AZER Post EA
Appendix A
Comment Letters

RE: STB Finance Docket No. 34836
Draft Environmental Assessment for Arizona Eastern Railway
Construction and Operation, Graham County, Arizona

ARIZONA DEPARTMENT OF TRANSPORTATION
STB DRAFT ENVIRONMENTAL ANALYSIS REVIEW COMMENTS

Suggested possible route. (Base map from Arizona Eastern Railway Safford Branch Project report)

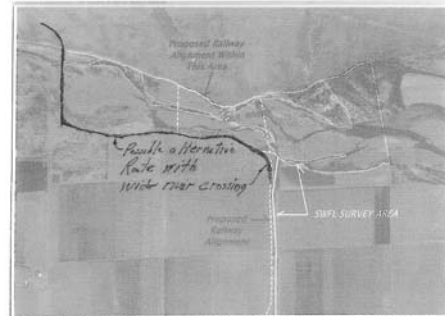
The farming operations will be impacted by the alignment of the railroad. Currently the proposed railroad track will divide the farm and cause a portion of the field to be less than 35 acres. This small piece of farm will need to have new concrete delivery ditches installed. It makes it difficult to bring equipment in to work the field and causes more land to be in turnarounds and borders, so net farming area will be lost (see sheet 3). This creates a hardship on the farmer and loss of revenues.

EXHIBIT A

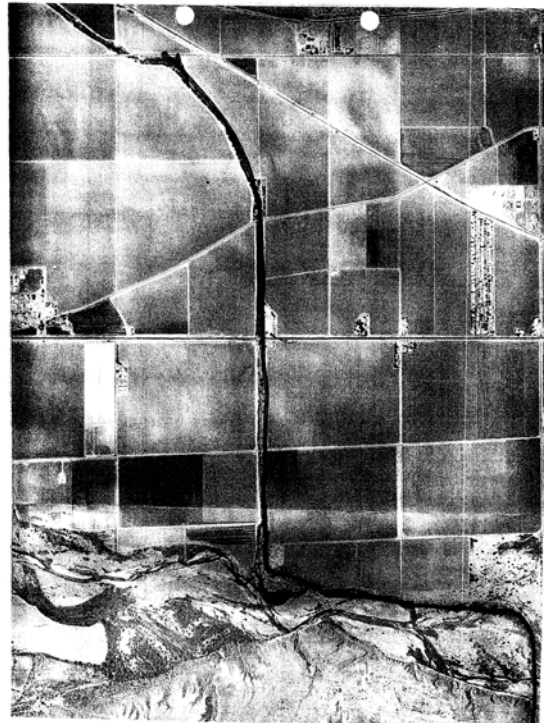
The best way to ensure that a project minimizes impacts to affected landowners is to choose the route through those lands that is preferred by the owners. Landowners are in the best position to know how their land is used, the future plans for the land, and the impact the Proposed Action will have on their land. Yet the Draft EA failed to consider the route proposed by the Claridges in a meeting with AZER representatives and other stakeholders held almost two years ago, June 29, 2006 ("Claridge Alternative," shown in Exhibit A).
